# Access Compliance Report

## Public Rights-of-Way

| Intersection ID: 9784                   | Main Street: FAIRMARKET_PL | Cross Street: THE_PLAZA                 | Location:              | NW                 |
| ADA ID: 12E611BADF24                    | Ramp Type: PerpDiag        | Initial Pass/Fail: Pass                 | Overall Compliance: No | Severity Score: 10 |

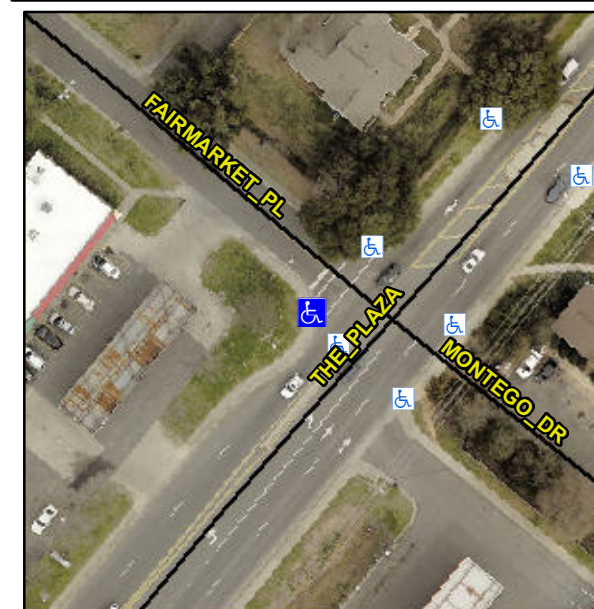
**Not Found, R304.2.1, R304.2.2-Perp, R304.3.2-Para, R304.5.3, R305.2**

| Compliance | Description           | Data   | Compliance | Description                 | Data  |
|------------|-----------------------|--------|------------|-----------------------------|-------|
| No         | Landing Length (in)   | N/A    | Yes        | DWS Provided?               | Yes   |
| No         | Landing Width (in)    | N/A    | Yes        | DWS Contrast?               | Yes   |
| No         | Landing Slope (%)     | N/A    | Yes        | DWS Length (in)             | 24.0  |
| No         | Landing X Slope (%)   | N/A    | Yes        | DWS Full Width?             | Yes   |
| N/A        | Landing Curb? (Y/N)   | No     | No         | DWS Offset (in)             | 2.5   |

**Remove & Replace Curb Ramp With Two New Directional Ramps or Equivalent.**
